PE1236/AA

Subject: Letter for consideration with Petition PE1236 in the name of Jill Campbell

Image of the location from Google Maps

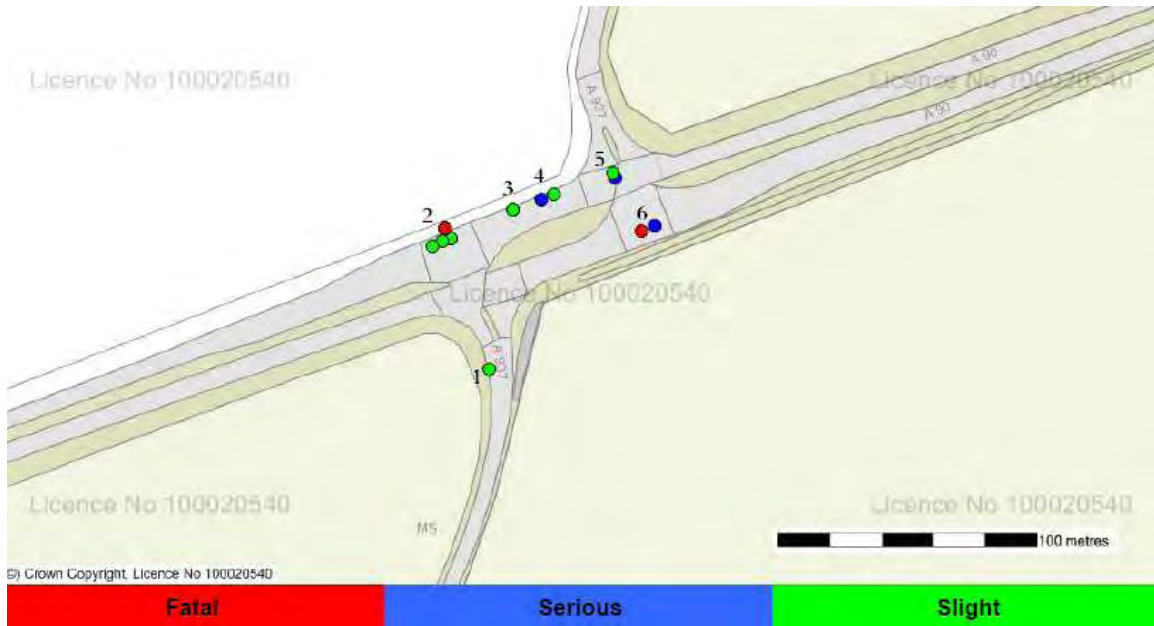
The most likely cause of accident is an over-speeding car colliding into the vehicle waiting to enter A90 or a car could have stopped on A937 Montrose side leg and the following car could have collided into it.

- Considering that it is quite a sharp curve, the possible recommendations could be to widen the curve to allow the drivers to reduce speed and then enter the A90 road given that the turning lane is already protected.

- The vegetation could be reduced and a hard-shoulder could be allowed for vehicles which break-down and used when traffic volumes may increase.

It is equally possible that the shadow from such vegetations may „hide“ the vehicle from the incoming traffic.

- The center line curve on the A937 Montrose side is not helpful for people who are wishing to travel to the on Laurencekirk side.
- A speed limit may be posted at the site

The high number of accidents at this location may be due to the weaving of the traffic at the protected turning to the A937 on Laurencekirk side. It's surprising to see that the traffic study detailed in the picture in PE1236/E page 73 does not include the protected turning lane in the design diagram and analysis. This could have missed the opportunity to consider the conflicts that would occur at this site.

- Contrary to the junction on the Montrose side, it can be seen the curve is quite easy and will allow the driver to reduce the speed and enter the road A937 on the Laurencekirk side. The only issue seems to be the speed at which the cars seem to enter the A937. The need is to post a speed limit.

There is not enough space to allow the driver to change lane. The only way is that the drivers keep a distance and maintain speed which will cause accidents

- The protected learning lane needs to be extended to ensure that the drivers have enough time to reduce their speed and accommodate for the preceding car and enter the curve

The accidents on this location seem to be a result of the incoming traffic coming from the A937 Montrose side leg to the A937 Laurencekirk side leg. This is as the curve on

the Laurencekirk side leg provides for speed reduction and as A90 is a trunk road, the cars approaching this road would rush to reach the protected turning lane.

- The petition calls for grade separation of A937 at this junction. Grade separation should reduce the accidents at this location, but the traffic from A90 still has to approach A937 by turning. For this an additional expenditure shall have to be paid to make a separate carriage way to accommodate the turning vehicles which would move towards the A937 and then combine with the traffic from this grade-separated section. There is no need for grade-separation as my earlier recommendation in Location 2 provides that the protected turning lane needs to be extended.

- The main idea of a staggered intersection such as this one is that the vehicle would have to travel along the length of the road and then have the ability to move to the other leg. However, strangely this is not the case here and the vehicle is allowed to head straight into the turning traffic.

- The only way to provide for this location is to close the gaps in the mid so that the vehicles cannot move. The solution is to provide a u-turn sufficiently far off from the point where the protected right lane is present, so that the vehicle would have the opportunity and time to weave from the lane to the protected lane.

Vehicles approaching from Laurencekirk side leg A937 to move to either A90 or A937 Montrose side leg would encounter this accident, as this would provide them direct collision with a vehicle which is moving straight.

Even if the grade-separation is provided for A937, this does not solve the problem for the vehicles which have to move from Laurencekirk to A90.

- The only way to provide for this location is to close the gaps in the mid so that the vehicles cannot move. The solution is to provide a u-turn sufficiently far off from the point where the protected right lane is present so that the vehicle would have the opportunity and time to weave from the lane to the protected lane.

Accidents on this location seem to be due to visibility issues. The shadows from the trees and the corresponding times of 1200 to 1800 hours (PE1236/B) correspond to the vehicles being hidden. Another cause of accidents could be due to the traffic moving from Laurencekirk to Montrose and colliding with the turning vehicle.

- Closing the gap will reduce the collisions between traffic from Laurencekirk to Montrose.
- Reducing the amount of vegetation at this location and placing it farther from the road to reduce the shadows on the road.
